FINAL FULL RESOURCE CONSERVATION AND RECOVERY ACT FACILITY INVESTIGATION WORK PLAN FOR SOLID WASTE MANAGEMENT UNIT 70 DISPOSAL AREA NORTHWEST OF LANDFILL WITH TRANSMITTAL AND RESPONSE TO COMMENTS

NAVAL ACTIVITY PUERTO RICO

11/4/2010

NAVY RESPONSES TO EPA COMMENTS DATED SEPTEMBER 16, 2010
ON THE TECHNICAL REVIEW OF THE
DRAFT FULL RCRA FACILITY INVESTIGATION WORK PLAN
SWMU 70 – DISPOSAL AREA NORTHWEST OF LANDFILL
DATED JUNE 30, 2010

FIGURE 1-3
SITE LAYOUT AND ECP/PHASE I RFI SAMPLE LOCATION MAP - 2006 AERIAL PHOTOGRAPH
SWMU 70-DISPOSAL AREA NORTHWEST OF LANDFILL
FULL RFI WORK PLAN
NAVAL ACTIVITY PUERTO RICO

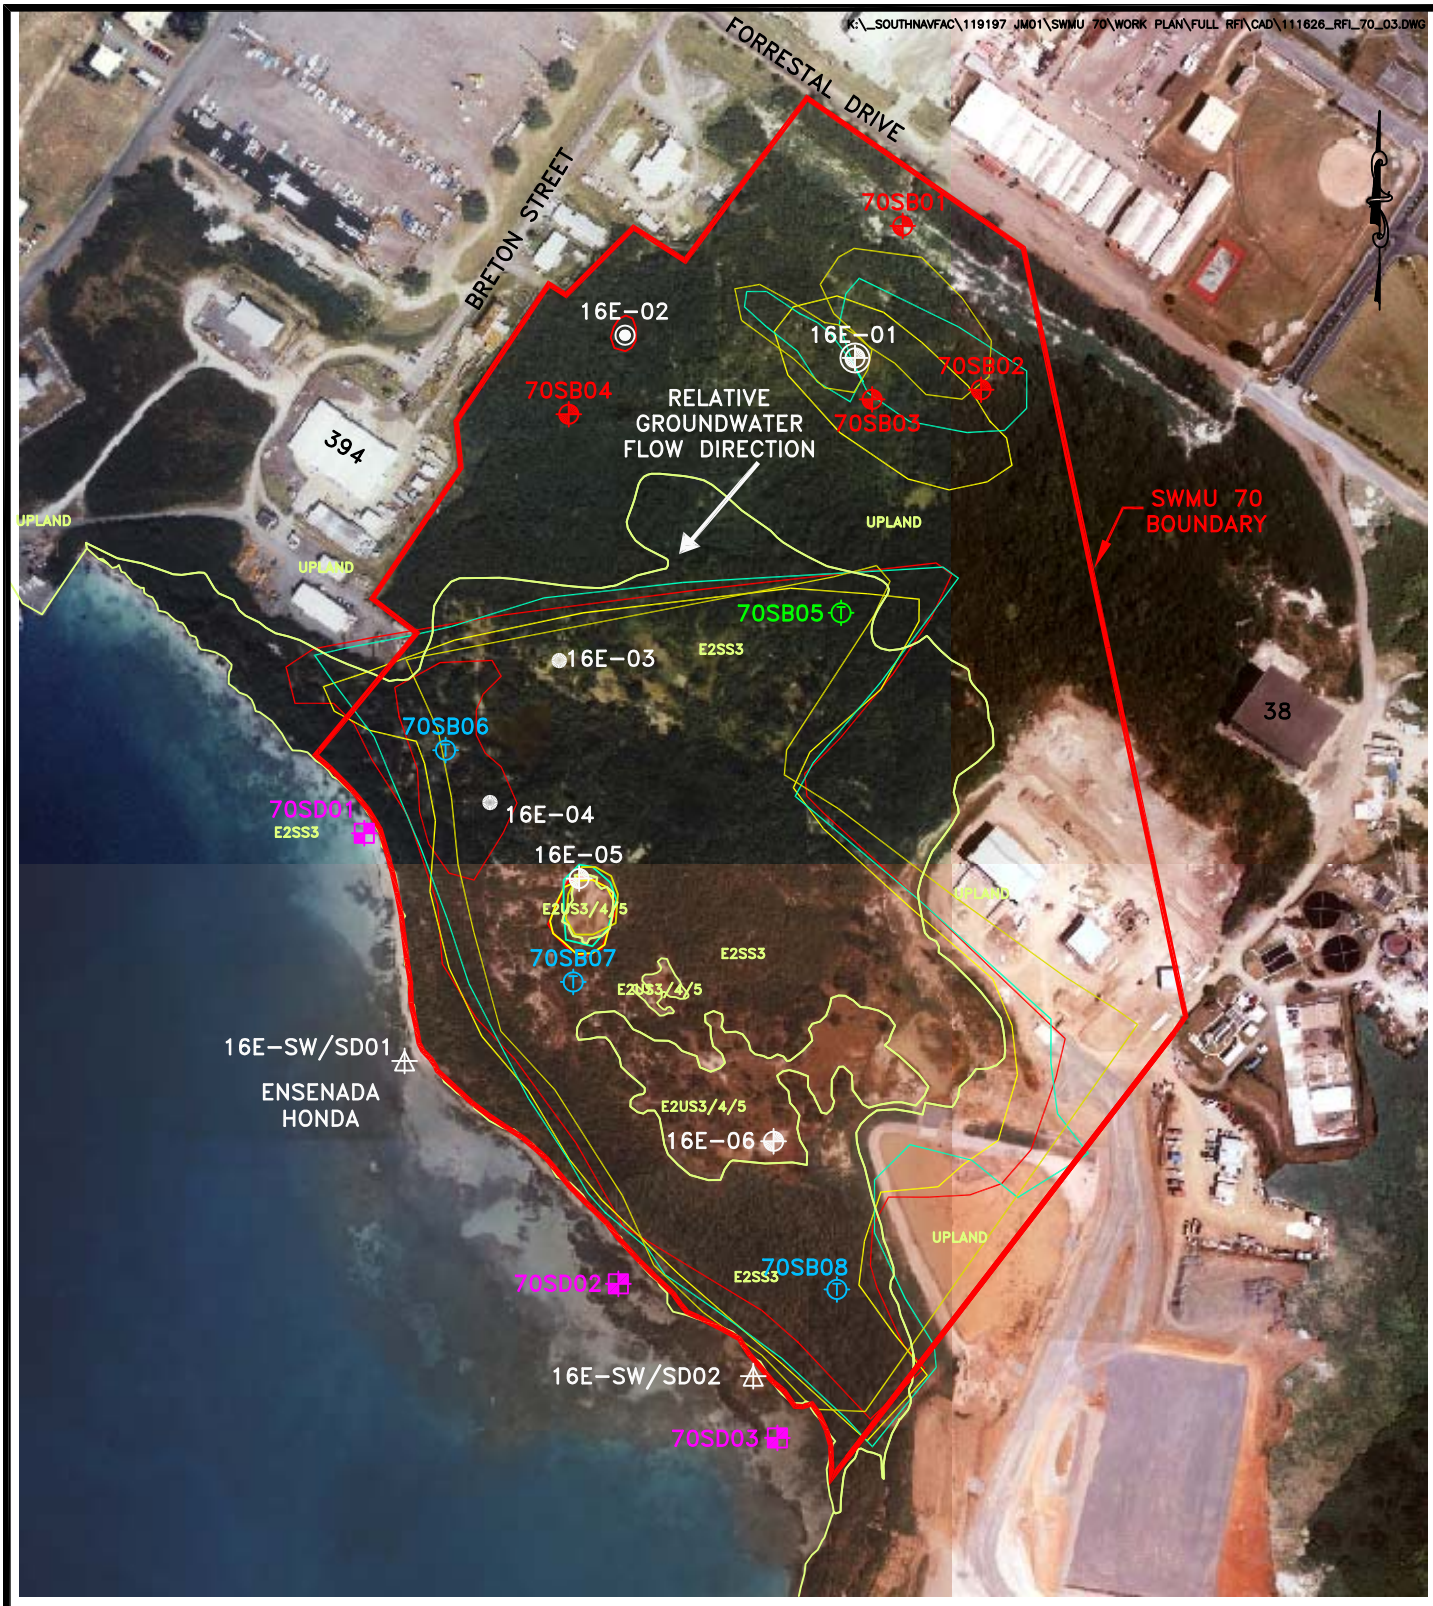
11. *Figure 1-3 of the Work Plan outlines three areas in the western portion of SWMU 70 (east and northeast of sample location 70SB06) in blue. According to the figure legend, this color denotes a "water boundary," which would seem to indicate that these areas may be surface water bodies, at least for part of the year. Standing water appears to be present in the largest of the three areas in the aerial photograph. However, except for Ensenada Honda, the Work Plan does not discuss the presence of surface water at the site. Revise the Work Plan to clarify if surface water bodies are present at SWMU 70, even if only for part of the year. If so, these areas need to be discussed in the Work Plan and investigated.*

12. *The link between groundwater and surface water at SWMU 70 has not been adequately described in the Work Plan. Figure 1-3 indicates that a large portion of SWMU 70 has been identified as estuarine wetlands, and the Work Plan details plans to collect 19 sediment samples in these areas. As noted in the General Comment 11 on Figure 1-3, the Work Plan does not discuss the presence of surface water at SWMU 70, other than Ensenada Honda. The presence of shallow groundwater is noted several times in the Work Plan. On page 4-3, Section 4.6.1.2 of the Work Plan states that groundwater sampling results will be compared to surface water (specifically, saltwater) screening. Although the rationale for this decision is not explained, it is possible that shallow groundwater in the wetland areas rises above the soil surface and exists as surface water at least part of the time. However, this occurrence is not mentioned in the text of the Work Plan. The presence of surface water, even if sporadic, could indicate the presence of additional ecological receptors and exposure pathways. Revise the Work Plan to include information about the connection, if any, between groundwater and surface water at SWMU 70.*

Navy Response to General Comment 11: Figure 1-3 of the Work Plan outlines three areas which appear to be surface water bodies for at least a part of the year. A discussion of the presence and proposed investigation of surface water has been added to Section 2.1, Section 3.4 and Section 3.5 of the Work Plan.

Navy Response to General Comment 12: Comment noted. A discussion of the presence of surface water has been added to Section 2.1, Section 3.4 and Section 3.5 of the Work Plan.

Navy Response to General Comment 1: A statement has been added regarding the direction of ground water flow. Figures 1-3, 1-4, and 3-1 have also been revised with an arrow to indicate the direction of ground water flow.

FIGURE 3-1
PROPOSED FULL RFI SAMPLE LOCATION MAP
SWMU 70-DISPOSAL AREA NORTHWEST OF LANDFILL
FULL RFI WORK PLAN
NAVAL ACTIVITY PUERTO RICO

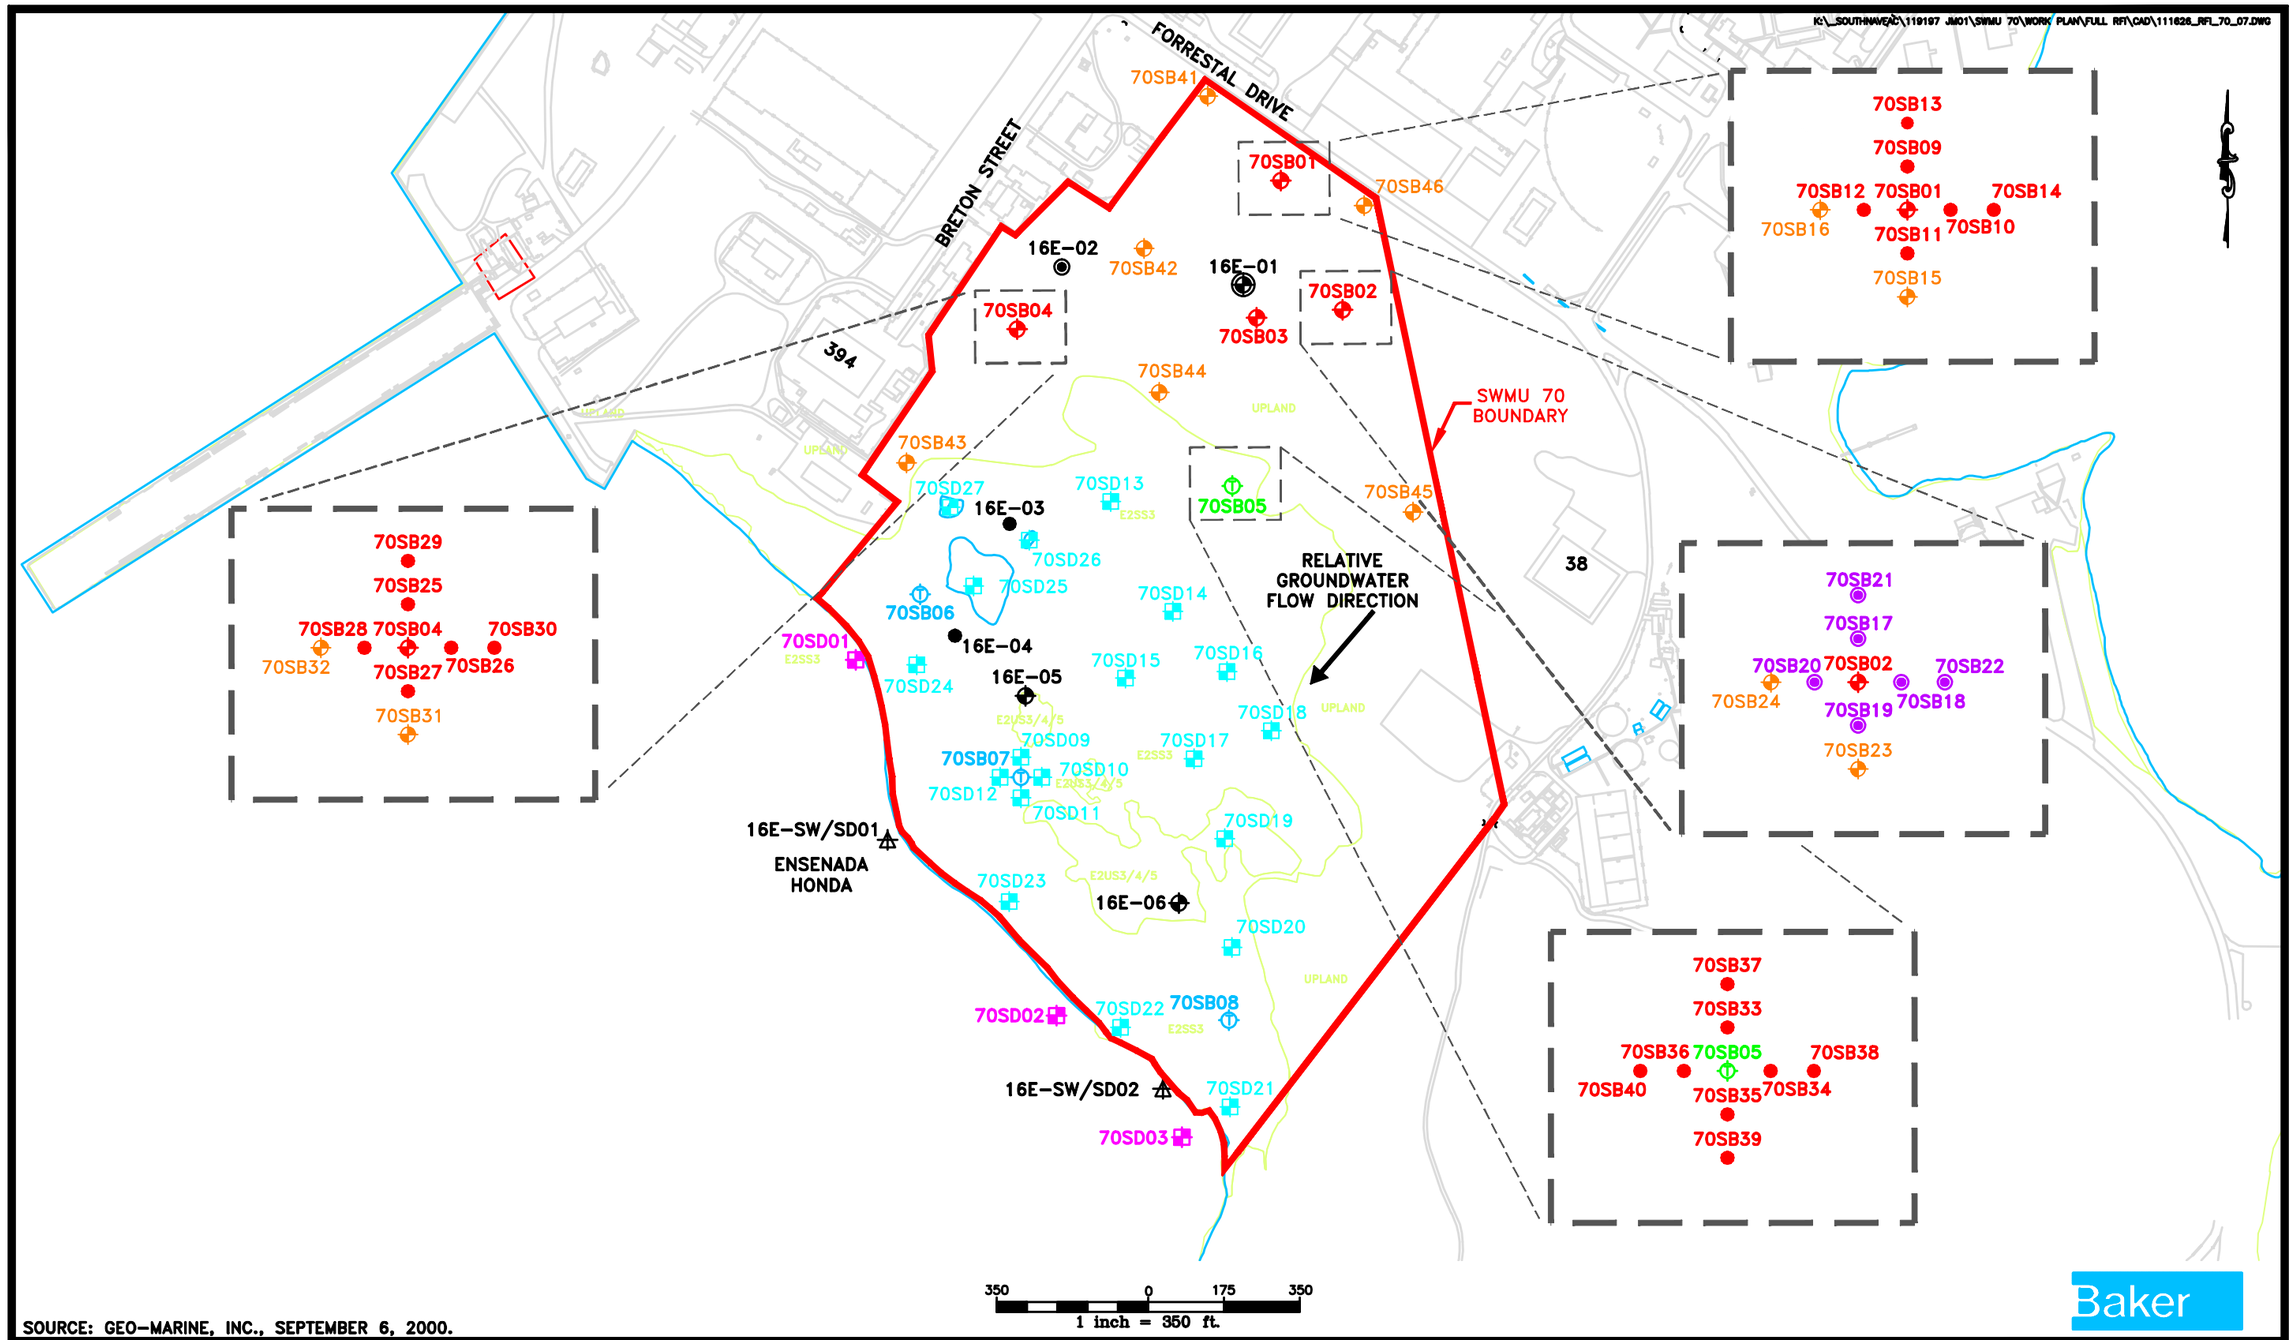
3. ***Section 3.1, Soil Sampling and Analysis Program, Page 3-1:*** *Under the first bullet of this section, two additional groundwater samples are proposed to delineate arsenic in groundwater; however, they are located south and west of the existing well 70SB01 and there does not appear to be any delineation of groundwater to the north or east of well 70SB01. Revise the Work Plan to discuss the rationale for the groundwater sampling around well 70SB01 or propose additional wells to fully delineate arsenic in this area.*

symbol/color-coding on Figure 3-1. Is it the intent to re-sample soils adjacent to the existing 70SB01 monitoring well location? Please clarify.

Navy Response to Specific Comment 3: The groundwater flow is to the south to southwest at SMWU 70. One (1) additional well has been proposed (70SB46) to the east of 70SB01 to further delineate the up-gradient area at the edge of SWMU 70. An additional statement explaining the groundwater flow at SWMU 70 has been added to Section 3.1 for clarification.

Navy Response to Specific Comment 13: The timing of the wetland delineation and the adjustments to the sample locations based on the wetland delineation are now provided in Section 3.7.7, stating that, "Soil and sediment sampling locations will be altered from those depicted on Figure 3-1 based on field delineated location of wetland."
